UNITED STATES PATENT AND TRADEMARK OFFICE

APPLICATION NO.	FILING DATE	FIRST NAMED INVENTOR	ATTORNEY DOCKET NO.	CONFIRMATION NO.
10/523,024	02/02/2005	Arcangelo Manfrotto	2520-1051	7456
466	7590	01/23/2006	EXAMINER	
YOUNG & THOMPSON 745 SOUTH 23RD STREET 2ND FLOOR ARLINGTON, VA 22202			SHAH, SAMIR M	
			ART UNIT	PAPER NUMBER
			2856

Office Action Summary

DETAILED ACTION

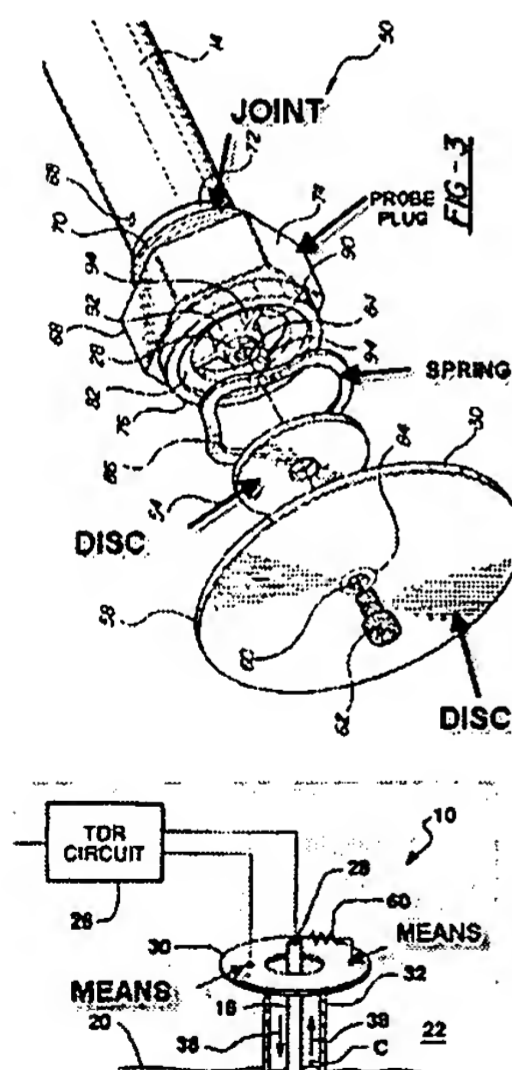
12. Claim 1 rejected under 35 U.S.C. 102(b) as being anticipated by Innes et al. (US Patent 5,943,908 henceforth "Innes").

As shown in the drawing on the top-left, Innes teaches a probe plug (74) in column 5, lines 20-25; it teaches a joint (70) in column 5, lines 14-17; it teaches a disc element (30) for an electric contact in column 4, lines 13-14; it teaches a spring (86) in column 5, lines 41-47. As shown in the drawing on the bottom-left, Innes teaches means for supplying probe and/or transmitting an electric signal to a circuit board.

Thus, Innes reasonably appears to teach and disclose every element of claim 1 and therefore anticipates this claim.
